TYPE III –Master Plan and Detailed Development Plan STAFF REPORT AND RECOMMENDATION

August 7, 2017

FILE NUMBER: CP-17-0002: General Development (Concept) Plan
DP-17-0003: Detailed Development Plan for Phase 1
NR-17-0004: Natural Resource Overlay District Verification

REQUEST: Approval for General Development Plan for Abernethy Place, a mixed-use project including Hotel, Multi-Family, Retail/Commercial and Office Use to be constructed in two phases over 10-years as well as a Detailed Development Plan for Phase 1 which includes construction of a Hotel and parking lots.

A100 – Site Plan

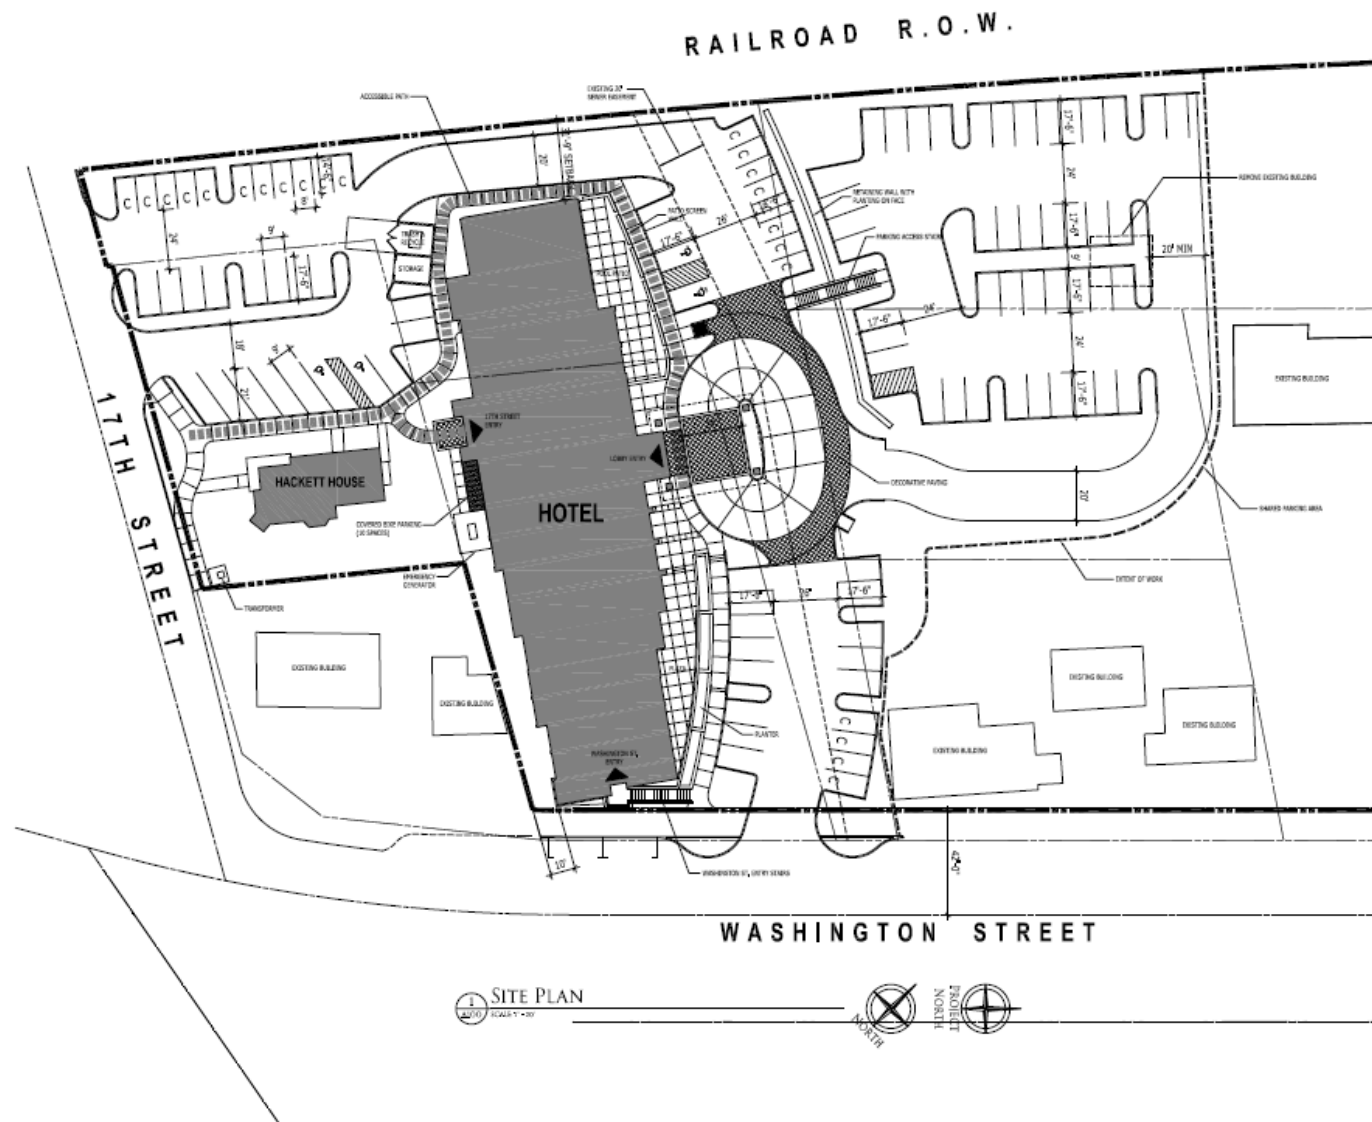
25. The applicant shall provide revised plans that include signs at the north main entrance that indicate the location of the covered bicycle parking at the south entrance. (P)

Finding: Complies as proposed. All parking stalls will meet the dimensional standards of either the City's standard or compact stall dimensions. See Site Plan, drawing A100 for dimensioned parking. 23 compact spaces are proposed, 22% of the total parking spaces provided.

Finding: Applicable. Bicycle parking is provided adjacent to the South side of the hotel, in close proximity to the Hackett House. See Site Plan, drawing A100.
